**CLASS 2 PERMIT MODIFICATION  
REQUEST WITH A REQUEST FOR  
TEMPORARY AUTHORIZATION FOR  
THE VOLUME 18 HWMA/RCRA  
STORAGE AND TREATMENT PERMIT  
FOR THE IDAHO NUCLEAR  
TECHNOLOGY AND ENGINEERING  
CENTER & RADIOACTIVE WASTE  
MANAGEMENT COMPLEX ON THE  
IDAHO NATIONAL LABORATORY**

## **PERMIT MODIFICATION REQUEST**

**CLASS 2 PERMIT MODIFICATION REQUEST INCLUDING A REQUEST FOR  
TEMPORARY AUTHORIZATION FOR THE HAZARDOUS WASTE MANAGEMENT  
ACT/RESOURCE CONSERVATION AND RECOVERY ACT STORAGE AND  
TREATMENT PERMIT FOR THE IDAHO NUCLEAR TECHNOLOGY AND  
ENGINEERING CENTER AND THE RADIOACTIVE WASTE MANAGEMENT  
COMPLEX (VOLUME 18)  
EPA ID No. ID4890008952**

**EXHIBIT D-2.** Sorting table, primary 14-by-18-ft secondary containment pan, additional secondary containment pans on the exterior, and the pan located on the interior of the primary pan (interior pan shown in red).

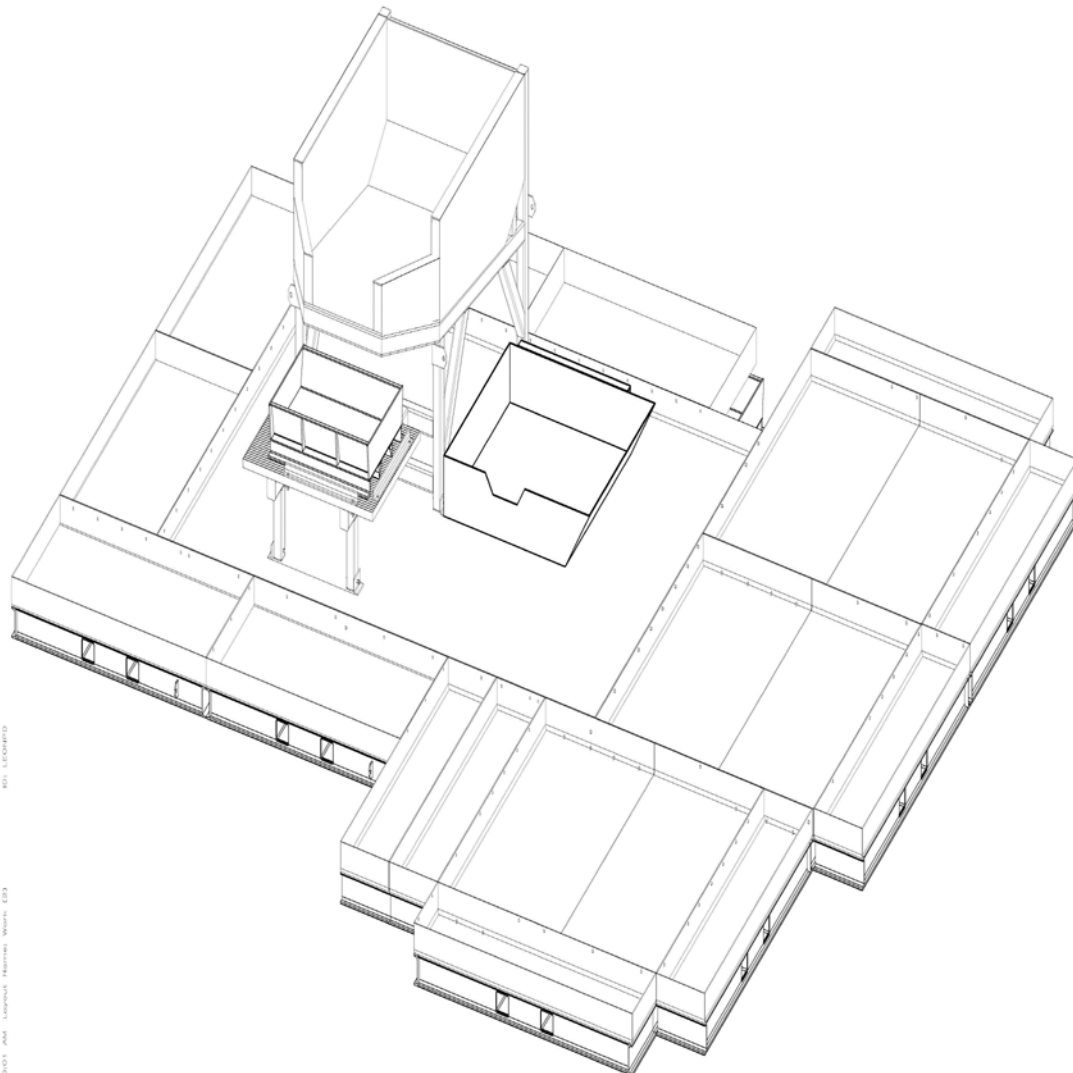
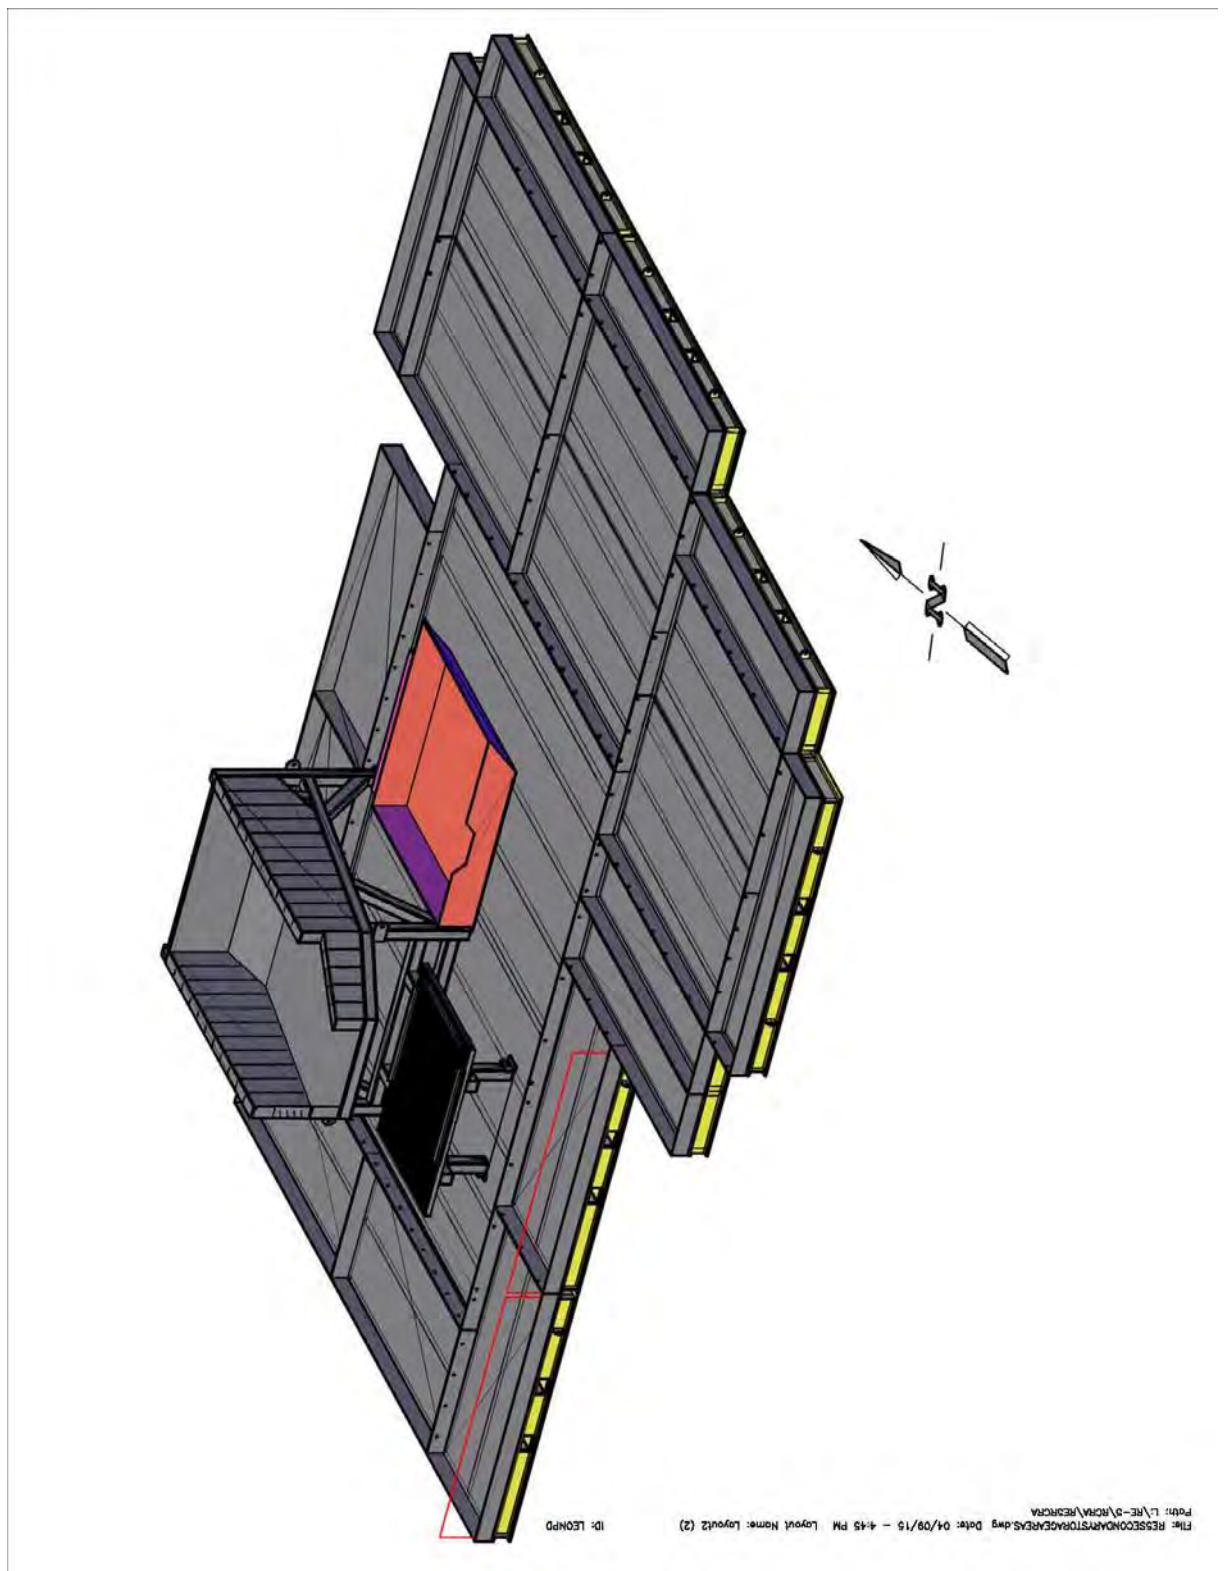
To support SRP operational requirements for WMF-1617 and WMF-1619, additional containment pans ~~have been~~ were added to the perimeter of the main sorting table secondary containment pan as shown in Exhibits D-1, D-1a, and D-2. Two 4' by 8' by 6' 7/8" secondary containment pans ~~have been~~ were added to the front (southeast side) of the main sorting table pan between the front of the sorting table and the excavator. These pans are attached to the main sorting table pan with u-shaped steel bridges over the joints or through the use of 1/2" diameter minimum bolts placed a minimum of 4 1/4" above the bottom of the pan. Lexan shields are placed on the southeast side of the secondary containment pans to prevent material from being projected under the excavator. Two additional pans were placed on both the southwest and northwest sides of the main sorting table as well as additional 2' x 9' pans shown in Exhibits D-1 and D-2. These pans are attached with u-shaped steel bridges over the joints or through the use of 1/2" minimum diameter bolts. All of the 4'x8' pans are placed on empty waste trays to elevate the pans to the correct height in relation to the main sorting table.

Three 9'x9' containment pans were placed to the northeast of the main sorting pan. These 9'x9' pans are connected to the main sorting pan with u-shaped steel bridges over the joints. Additional bridges were placed at any exposed critical pan junctions.

Also shown in Figure D-2 (in red), is an inner containment pan (5' by 6') that is used in support of the sorting table operations for initial drum processing activities (removal of lids and removal of drums from overpacks), use of the spiking tool to facilitate removal of waste from the drums, and for containment and absorption of liquids that may release during removal of drums from the overpack containers. This inner pan was added as an extra level of containment during these processes to prevent waste from entering the secondary containment within the treatment area. The inner containment pan ~~will be~~ is operated under the same conditions as the sorting table.

**EXHIBIT D-4.** [Example Schematic](#) of Drum Compactor [used at WMF1617 and WMF-1619](#)

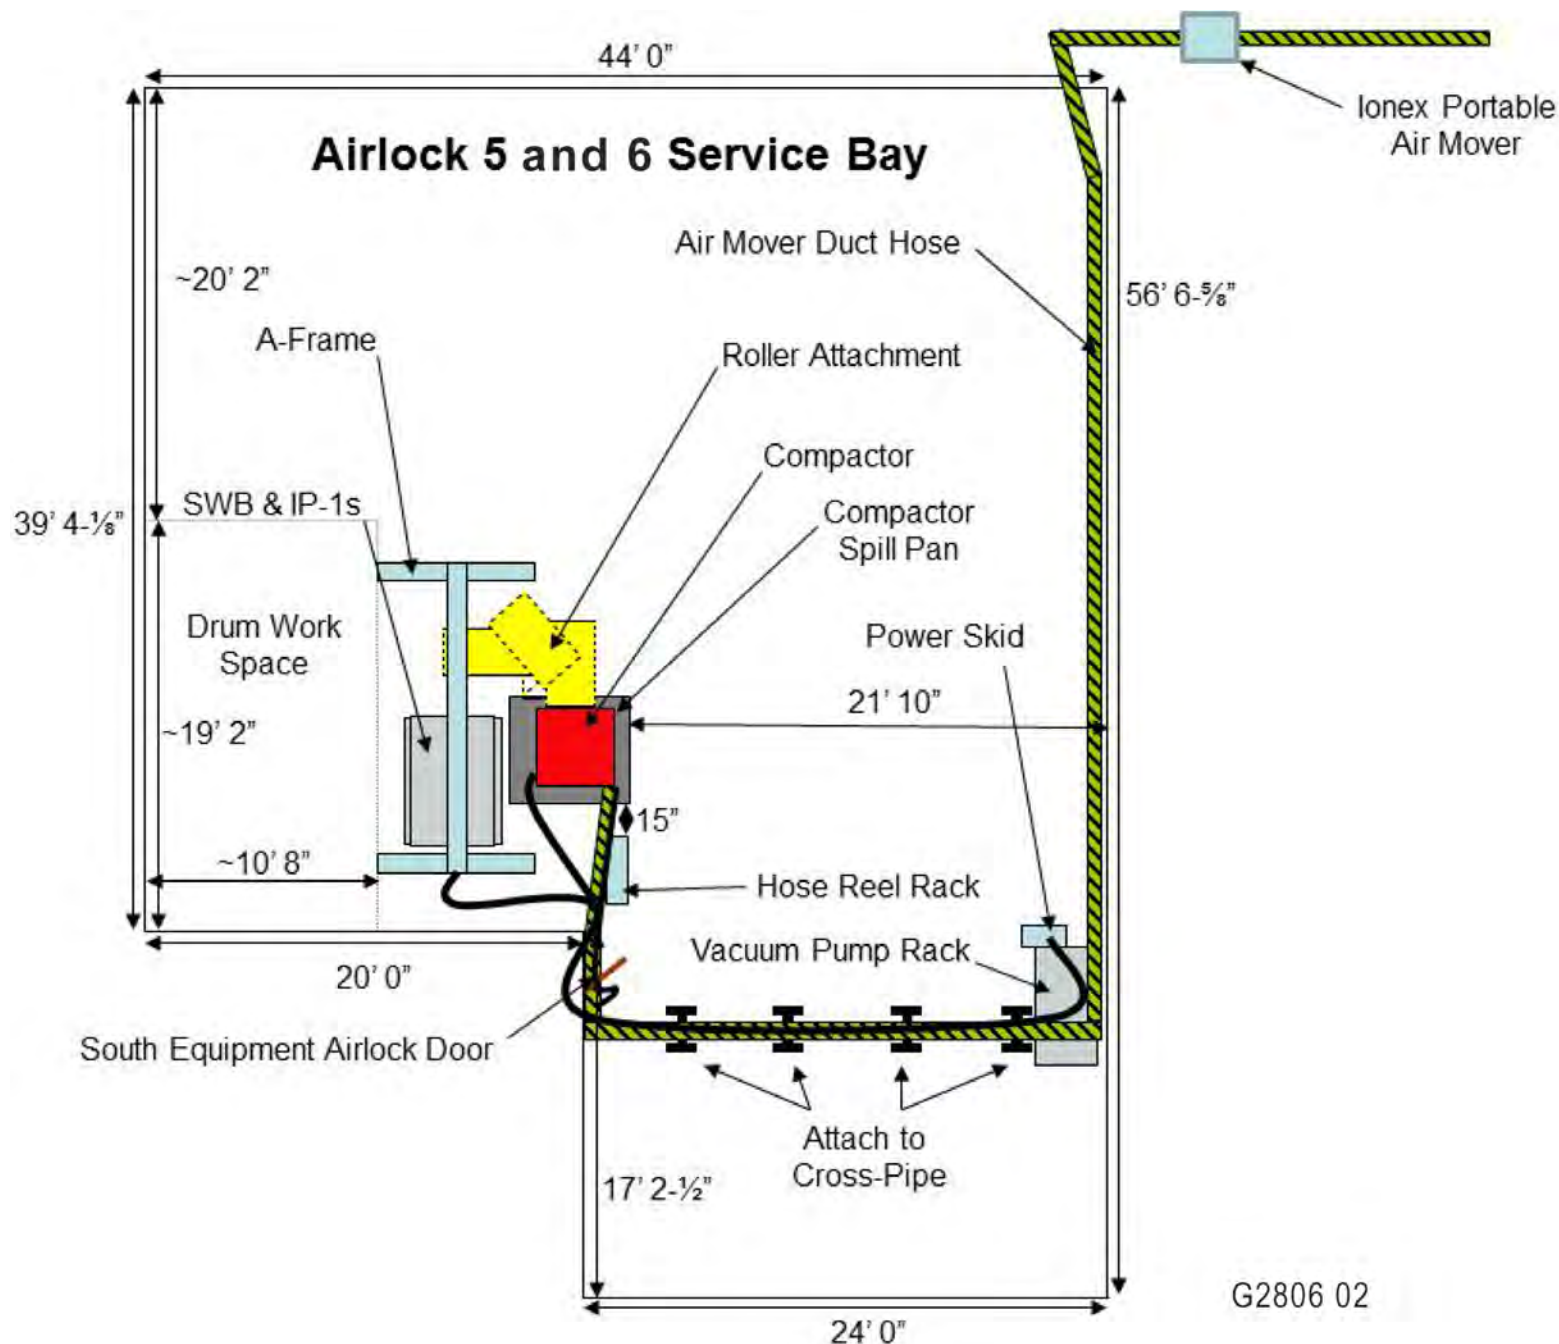
The drum compactor (Exhibit D-4) is constructed of carbon steel. The empty drum carcass is placed in the compactor either vertically upright or upside down. During compaction, a large diameter mast head presses down on the drum, causing it to collapse downward as it is compacted. Total time for the compaction cycle on each drum is approximately 55 seconds. Drum compaction ~~will be~~is performed with the door of the compactor closed and latched, for purposes of safety.

**EXHIBIT D-79.** WMF-1619 Retrieval Enclosure Camera Plan [for SRP and DRP Operations](#)

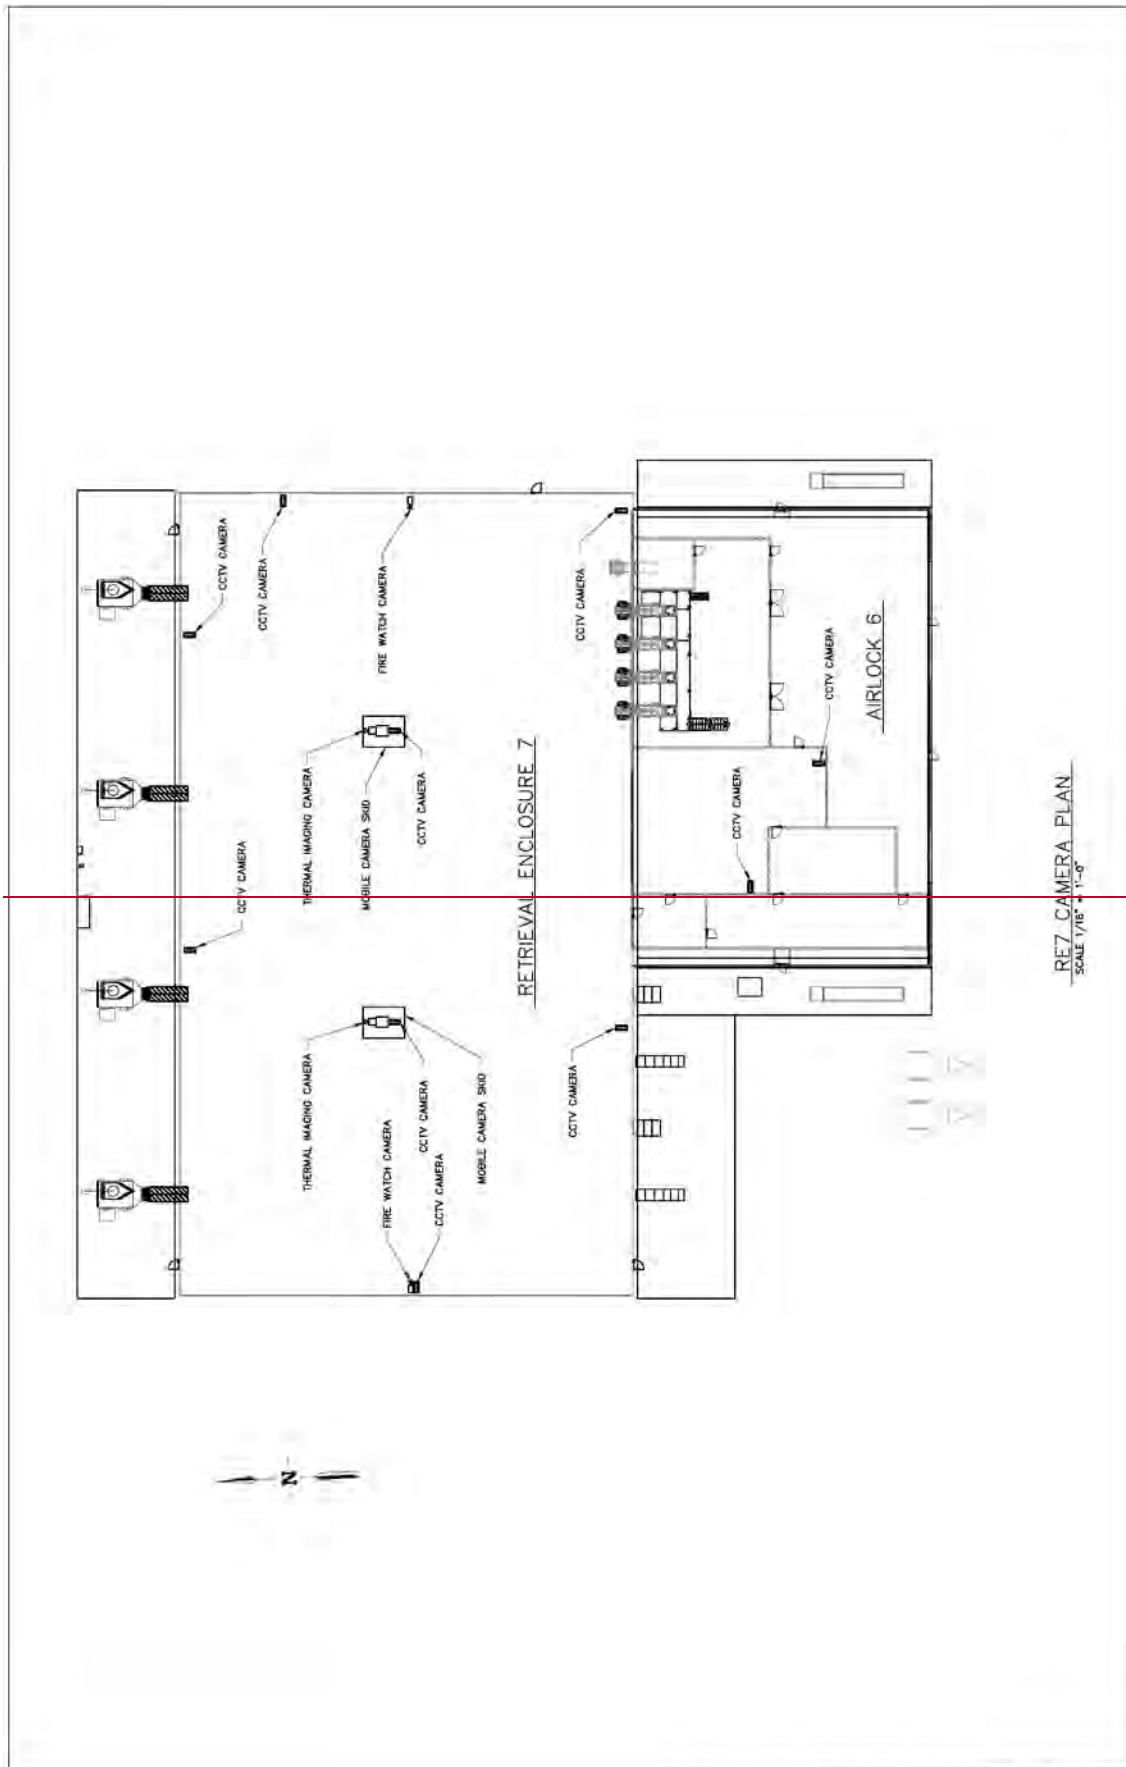
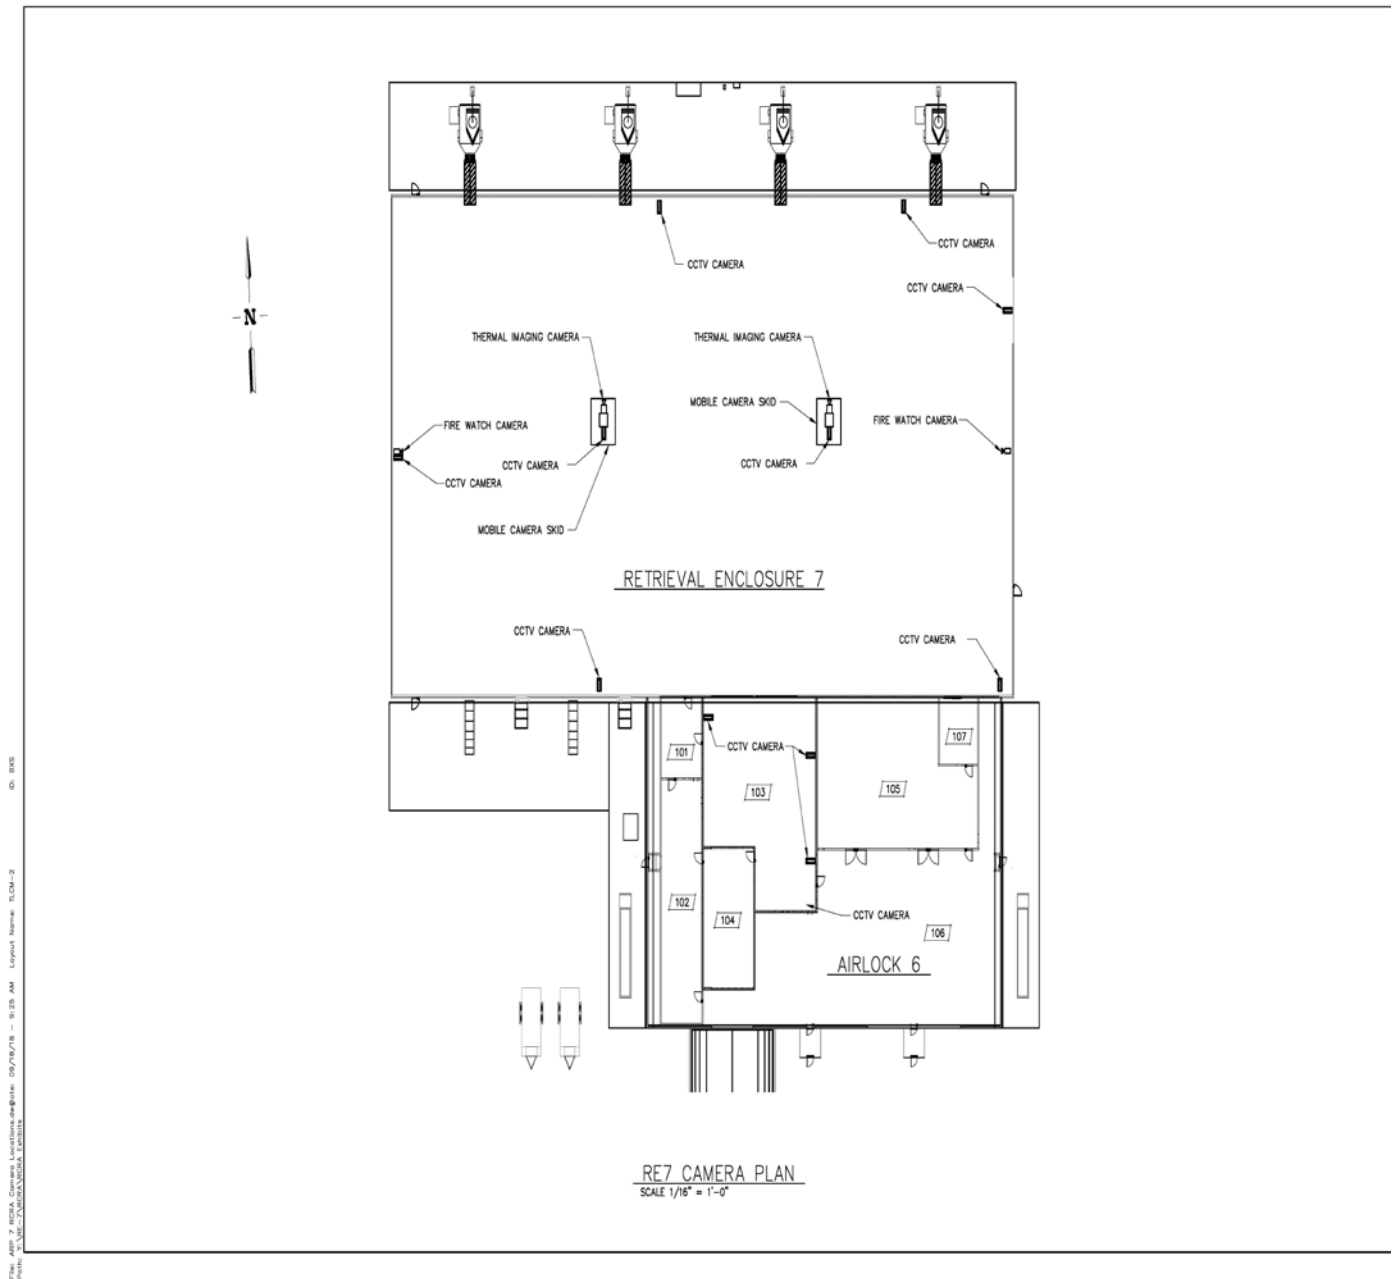
The sorting table activities performed inside the retrieval enclosure are observed through either excavator mounted cameras or cameras located within the facility (see Exhibit D-3 for camera locations [within the WMF-1617 RA and see Exhibit D-7 for the WMF-1619 Retrieval Enclosure Camera Plan](#)) that broadcast a video feed to the operations control room. The operations foreman directs the operation through viewing these camera feeds and communicates by radio with the equipment operator.
